Meeting: 9/18/2025
Applicant: John Holmes, Evian Partners
Owner: John Holmes, Evian Partners

Location: 210 S. Seventeenth St. **Parcel ID** 94 N E 034
District: Ft. Sanders NC
Zoning: RN-5 (General Residential Neighborhood)
Description: Queen Anne, c.1910

9-C-25-HZ
APPLICATION FOR CERTIFICATE OF APPROPRIATENESS

PROPOSED DWELLING AT 210 17TH AVE

2 REAR ELEVATION
1/8" = 1'-0"

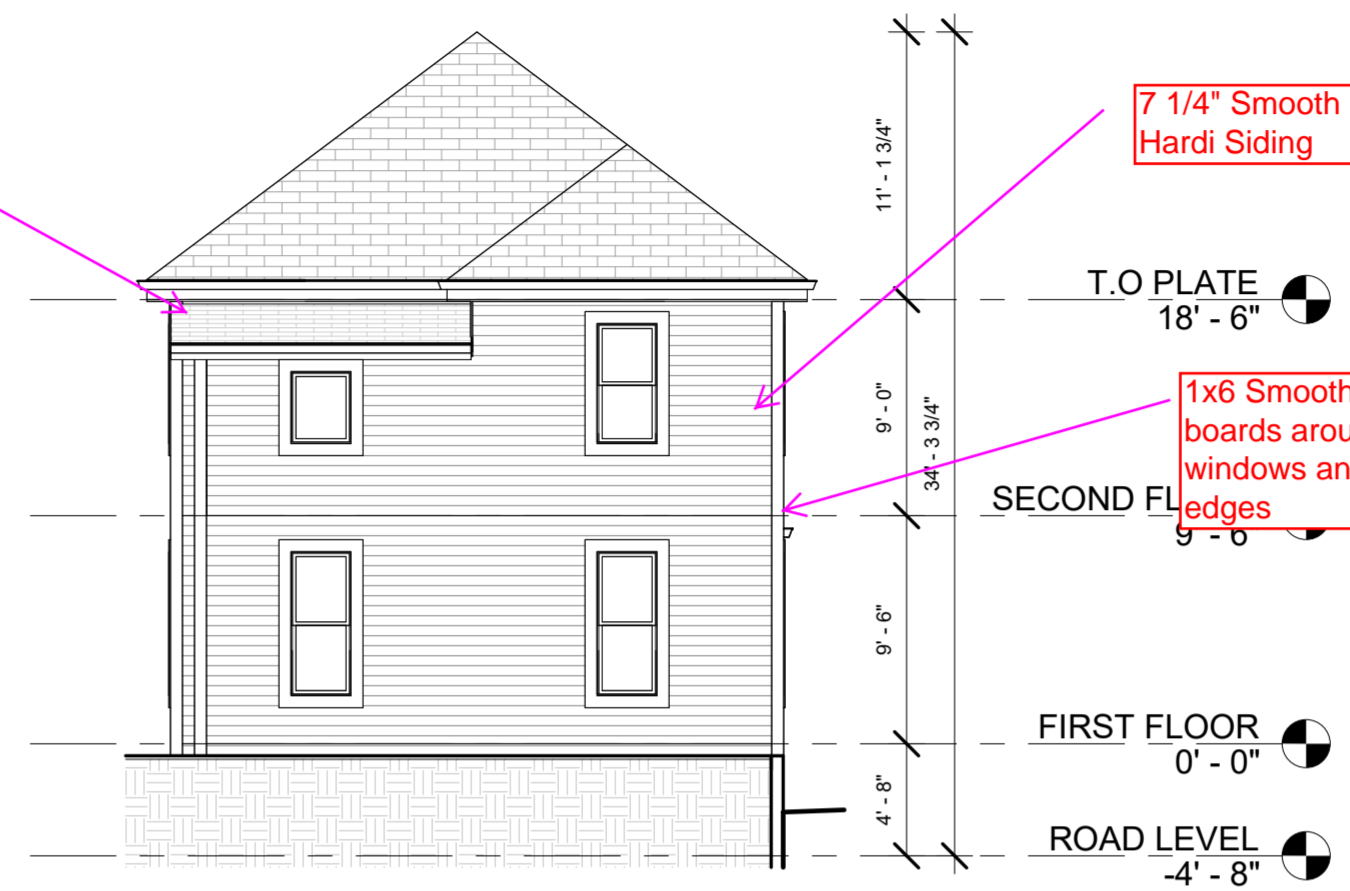
4. The location of the rear, second-story addition is appropriate. The new shed roof will have a lower slope than one removed but is similar in nature and not visible from the public street. It could be removed without adverse effect

1 FRONT ELEVATION
1/8" = 1'-0"

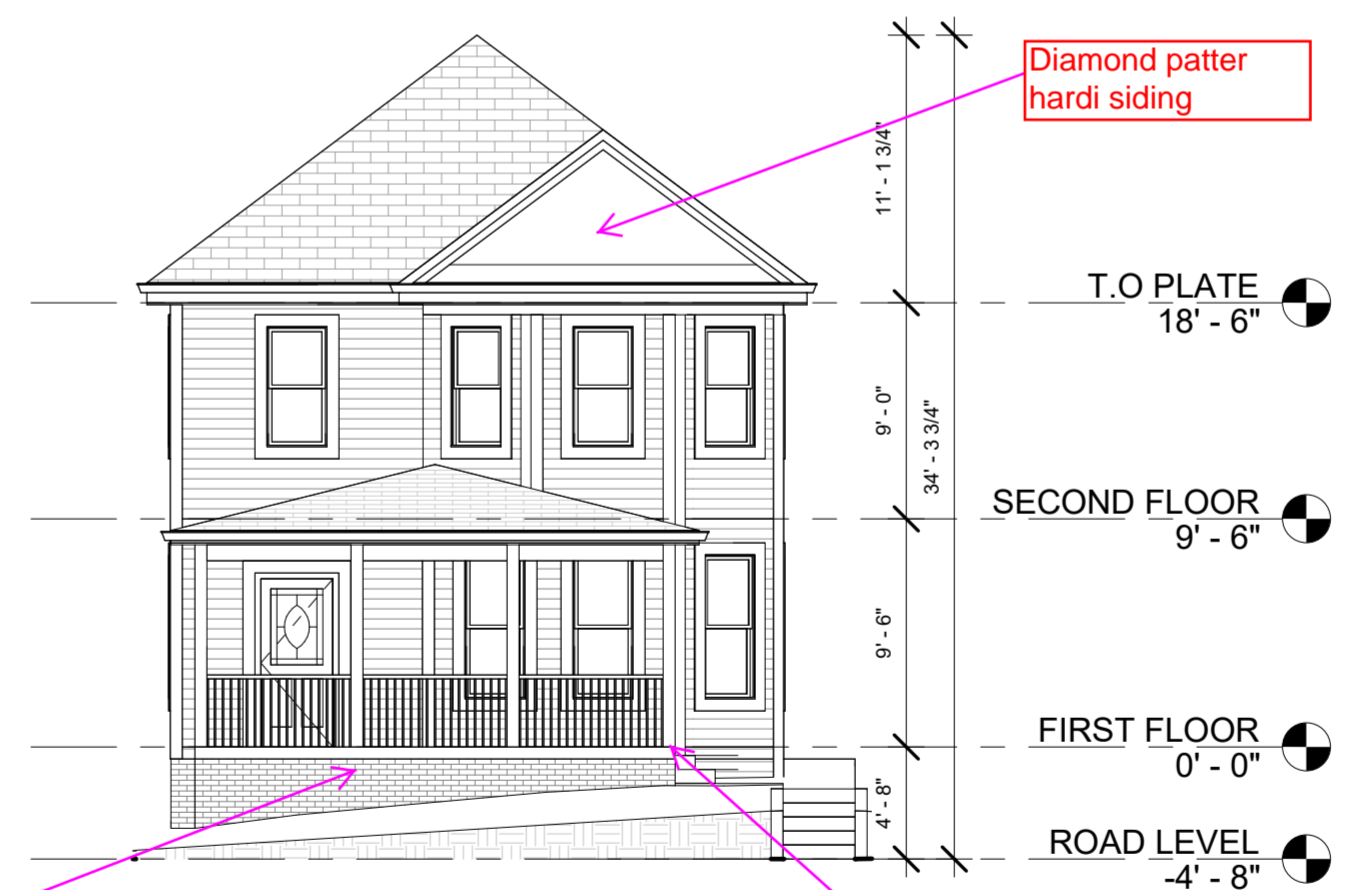
3. The existing enclosed front porch no longer retains historic integrity and removal is appropriate. The proposed replacement porch matches the footprint of the original porch and will rest on a reconstructed foundation using the existing brick, which is appropriate. The proposed materials are compatible with the house, apart from the supports. The porch posts should be at least 10" square, with the final design sent to staff for review. Reducing the number of posts and including brick bases could also be appropriate.

- 1) final site plan to meet City Engineering requirements for parking;
- 2) retention or replication of corner boards and window trim, as depicted on the elevation drawings;
- 3) retention of character-defining features such as partial cornice returns and façade gable details; and
- 4) the porch supports shall be at least 10" square posts, with the option of reducing the number of posts and including brick bases, with final design sent to staff for review.
